RE: Young Ranch Resource Quarry, File No. M-2021-009, 112 Construction Materials Reclamation Permit Application, Adequacy Review No. 3

Date: March 31, 2022
To: Amy Eschberger and Michael Cunningham, DRMS
From: Rob Zuber, DRMS
RE: Young Ranch Resource Quarry (M-2021-009), Third Adequacy Review,
Emphasis on responses to adequacy item 96 and other items related to surface water

Date: April 6, 2022
To: Amy Eschberger
CC: Jason Musick, Michael Cunningham
From: Zach Trujillo
RE: Young Ranch Resource Quarry, DRMS File No.
M-2021-009 Technical Adequacy Review No. 3

Figure 1. Screenshot of Active WRL Model from GALENA.

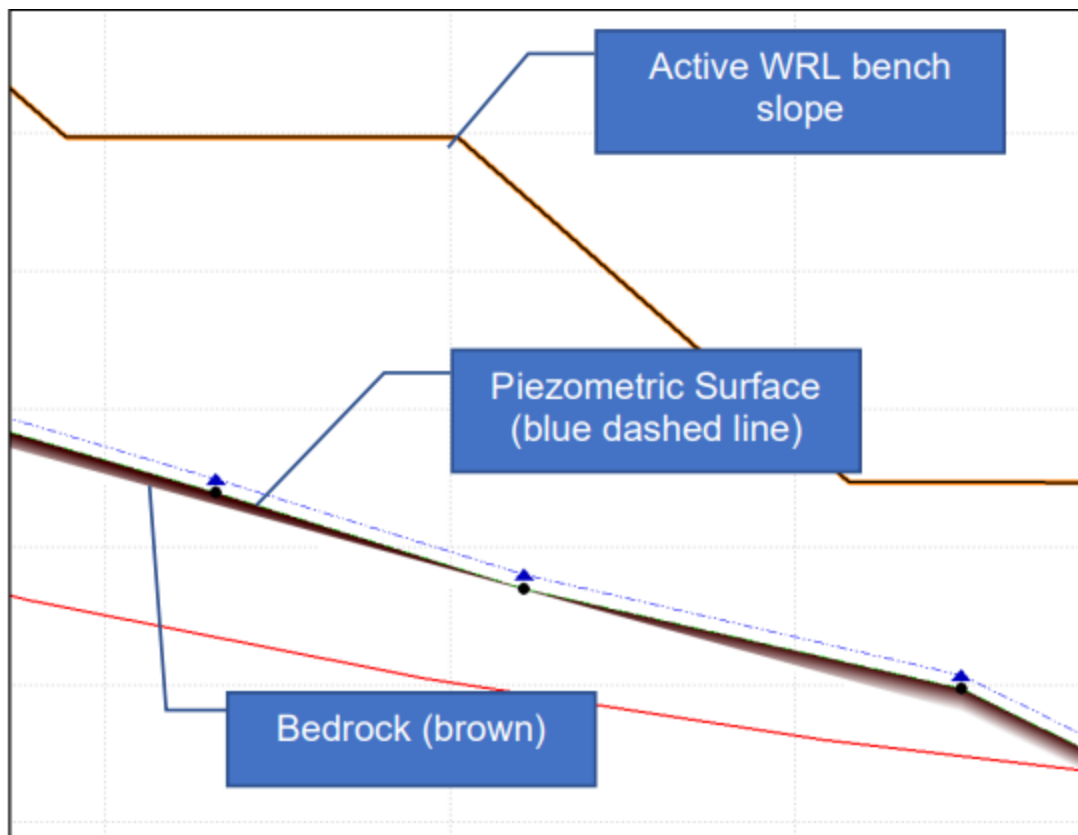
- *Additionally, please update Section 6.5 geotechnical slope stability report and analyses to discuss and account for groundwater levels consistent to the observed site conditions noted in the Division's August 4, 2021 inspection.*

YR: In the Slope Stability Exhibit, Impact of Surface Water Infiltration subsection of Exhibit 6.5, the presence of groundwater is discussed. All slope stability analyses assume a piezometric surface immediately within the soil profile of the natural ground. Due to the scale of the WRL sections, this piezometric surface can be difficult to see in the GALENA outputs. An example of the piezometric surface from a zoom window in GALENA is shown in Figure 1 for reference.

This piezometric surface represents groundwater that would produce the seep identified in the August 4, 2021 site visit.

Language has been added to the Slope Stability Exhibit, Impact of Surface Water Infiltration subsection to emphasize that this piezometric surface is how the groundwater in the area is accounted for in the slope stability analysis.

Based on the additional comments and clarification regarding the existing piezometric surface and seeps, **this item has been satisfied and no further comment is necessary.**
